# UNITED STATES PATENT AND TRADEMARK OFFICE

APPLICATION NO.	FILING DATE	FIRST NAMED INVENTOR	ATTORNEY DOCKET NO.	CONFIRMATION NO.
09/811,506	03/20/2001	Mitsuharu Nakamura	040894-5647	8902

# Office Action Summary

## DETAILED ACTION

FIG. 5

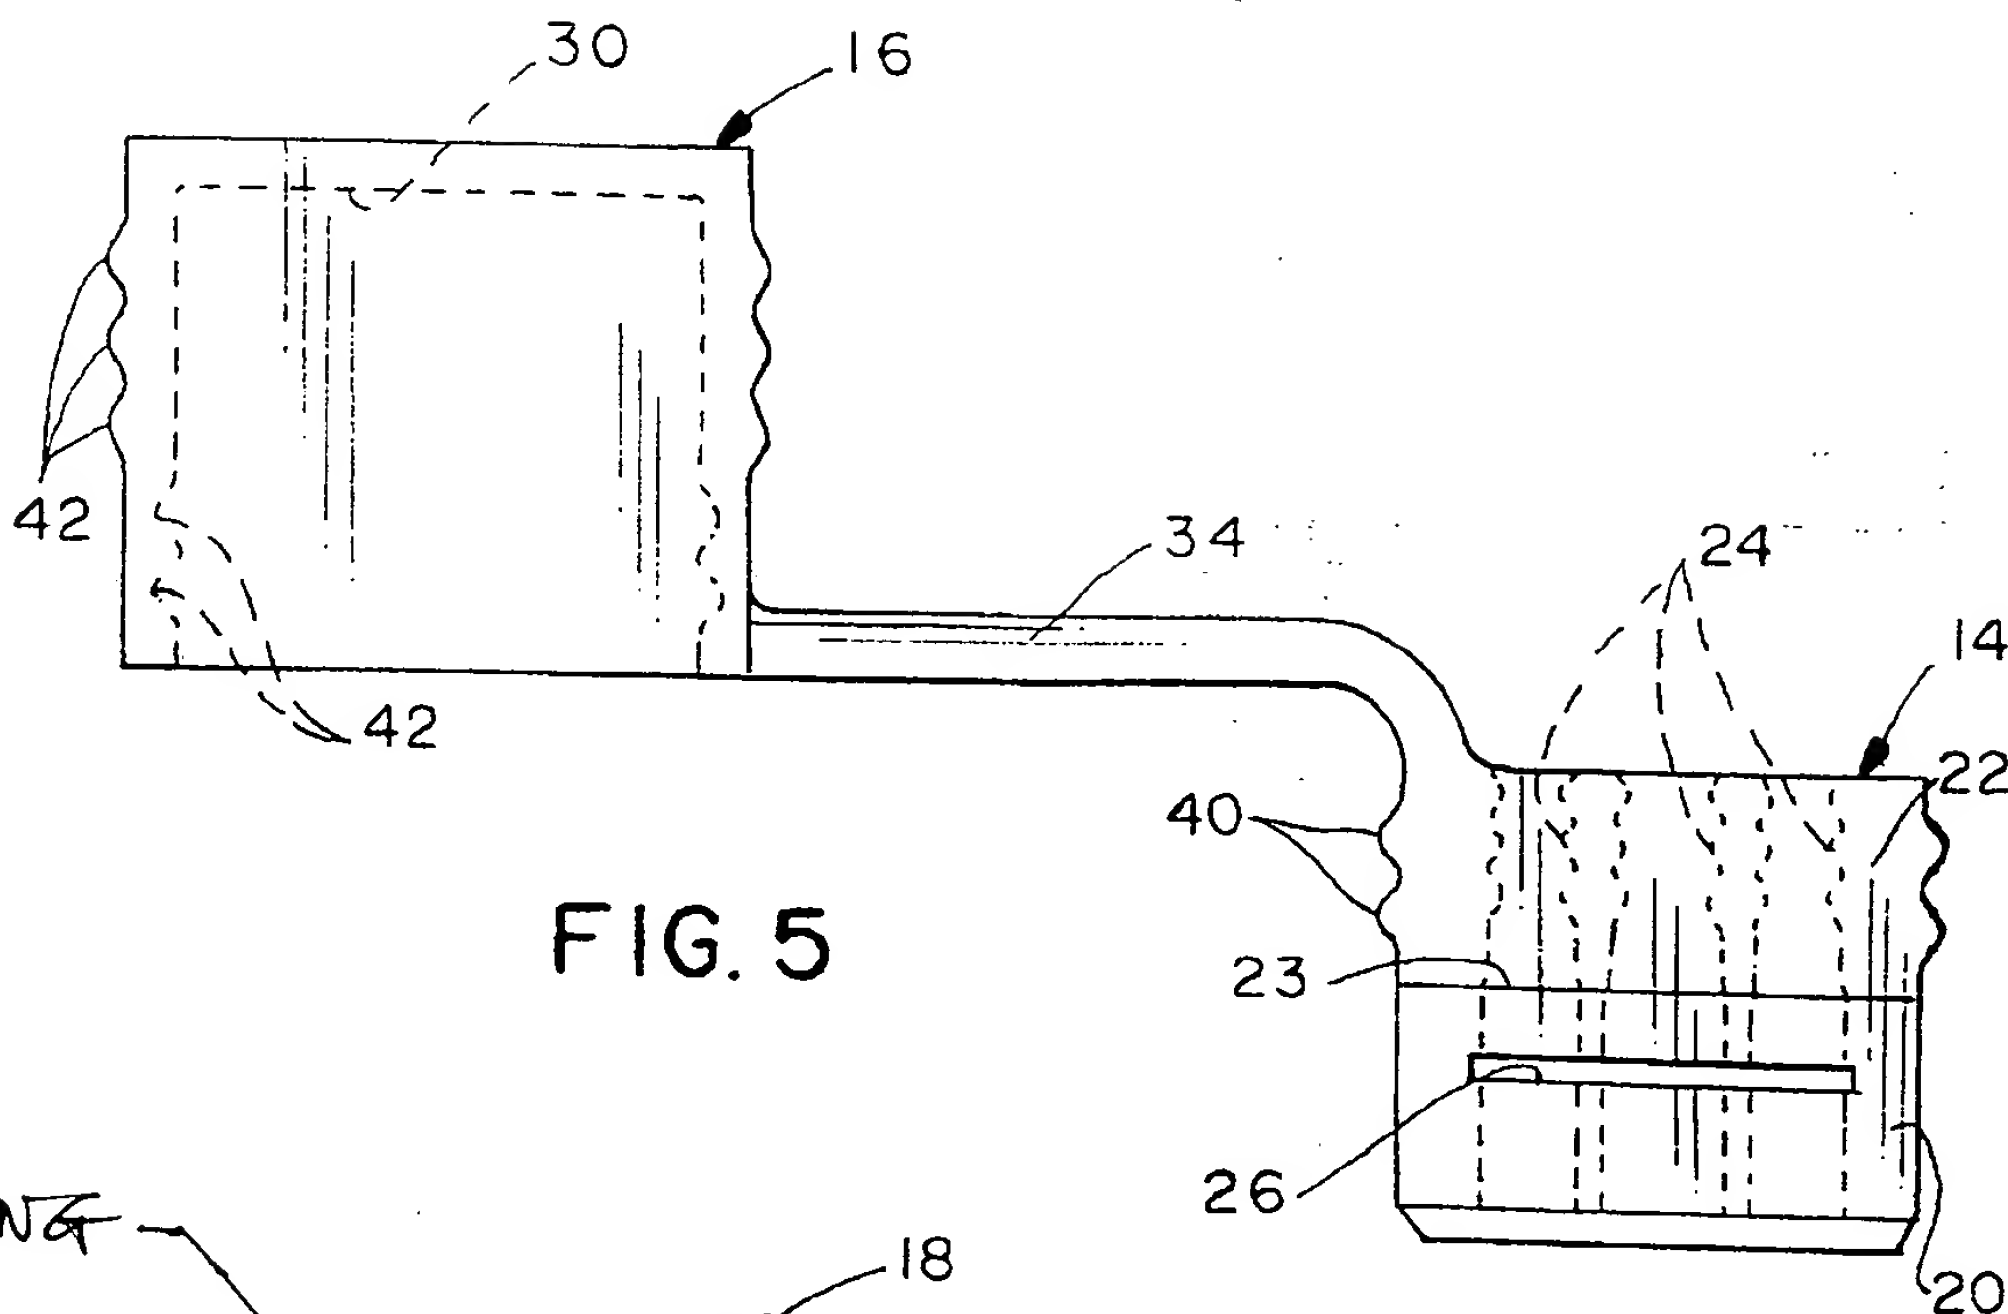
Marshall et al. discloses a dustproof cover assembly [figures 4-5] comprising:

- a cap-shape cover [16] having an open end and a closed end;
- a packing protecting portion [see attachment] extending from an end of an opening of a peripheral wall of the cover in a continual longitudinal direction, and inner surface of the cover includes a lip [see attachment] separating the packing protecting portion from the closed end of the cover;
- the cover is fitted to a connector [12, 14] so as to cover a front end fitting surface of the connector and the packing protecting portion covers a packing [see attachment] exposed around an outer peripheral portion of the connector;
- an inner peripheral surface of the packing protecting portion is formed in such a manner as to be brought into contact with the packing [figure 3]; and

FIG. 4

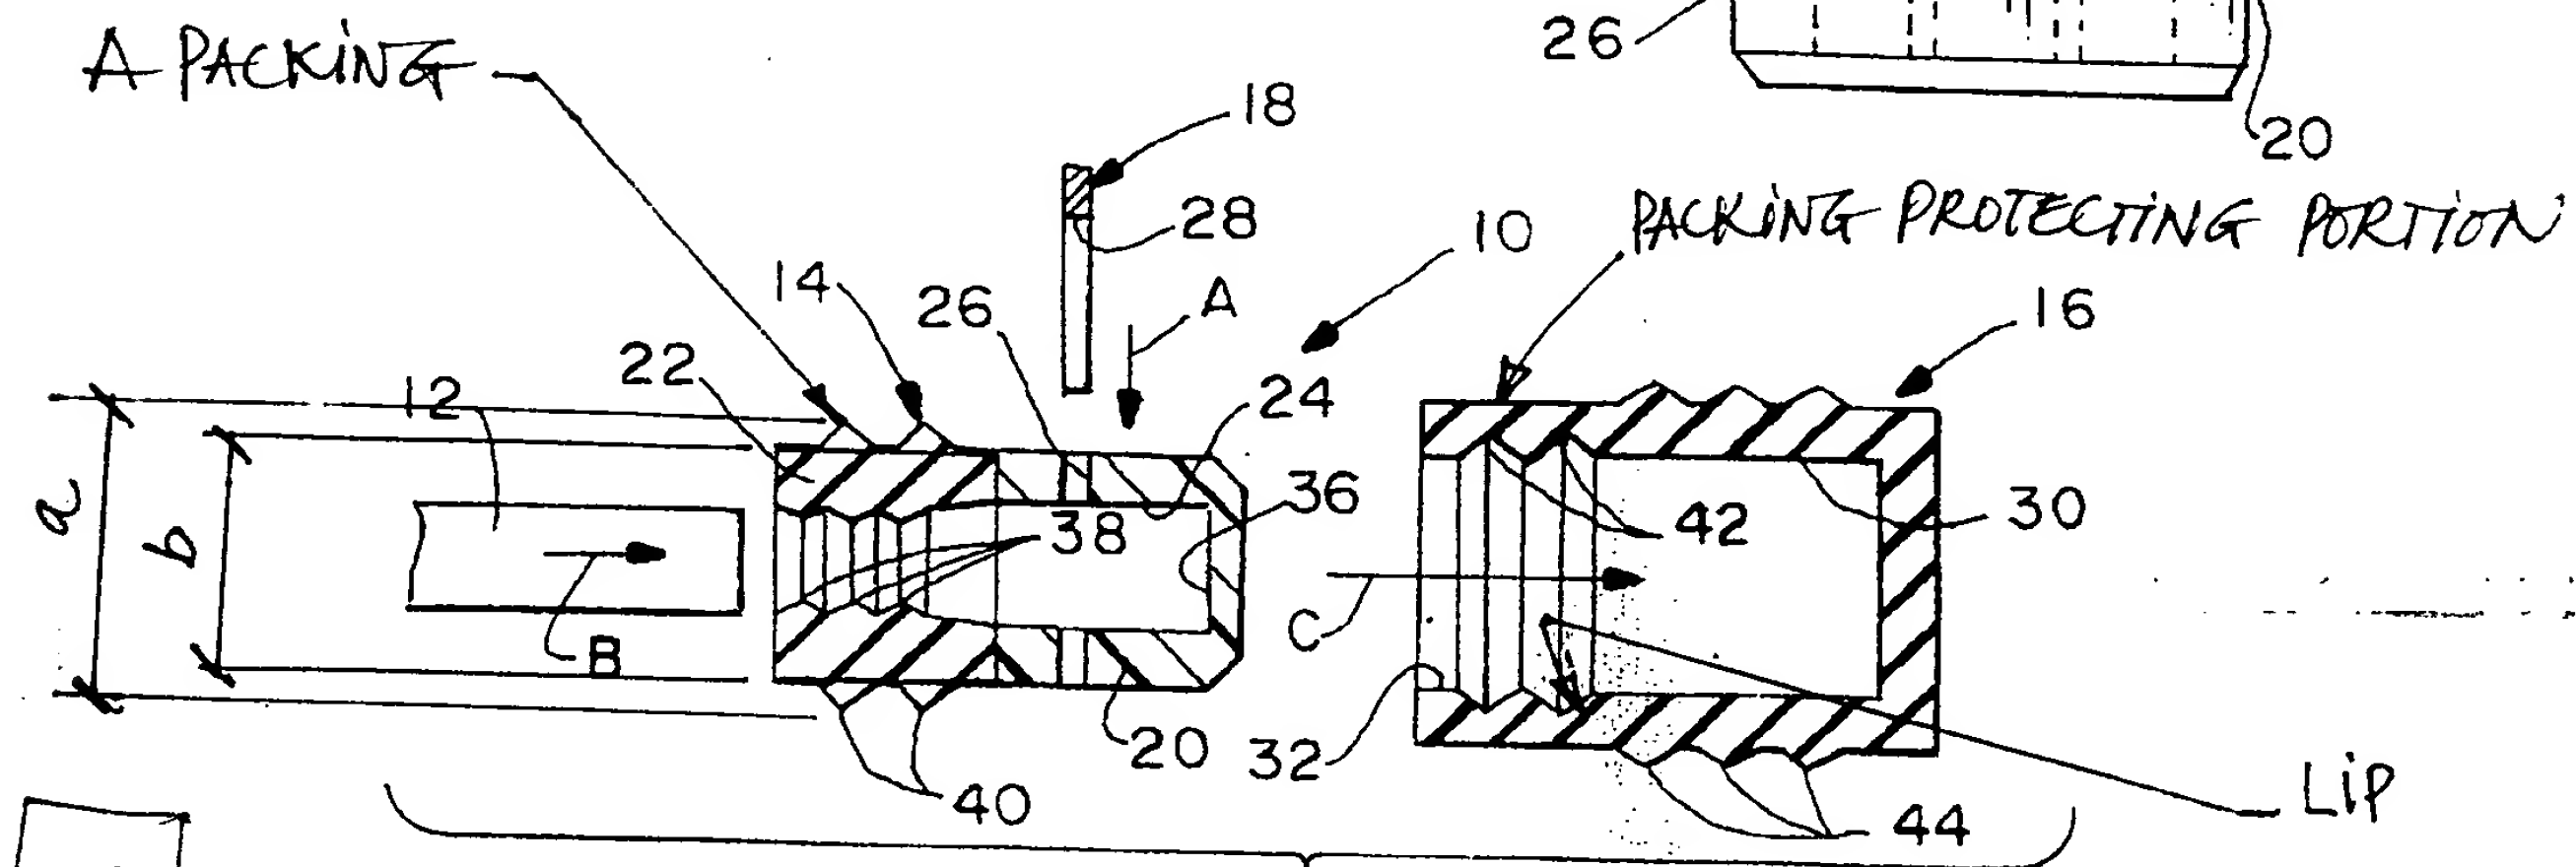
- as best understood by examiner, Marshall et al. further discloses the connector extending in a direction away from the packing, and the packing having a greater sectional dimension (a, see attachment) along a plane (a plane is perpendicular to the insertion of the connector into the cover) than a cross sectional dimension of the connector along the plane [b].
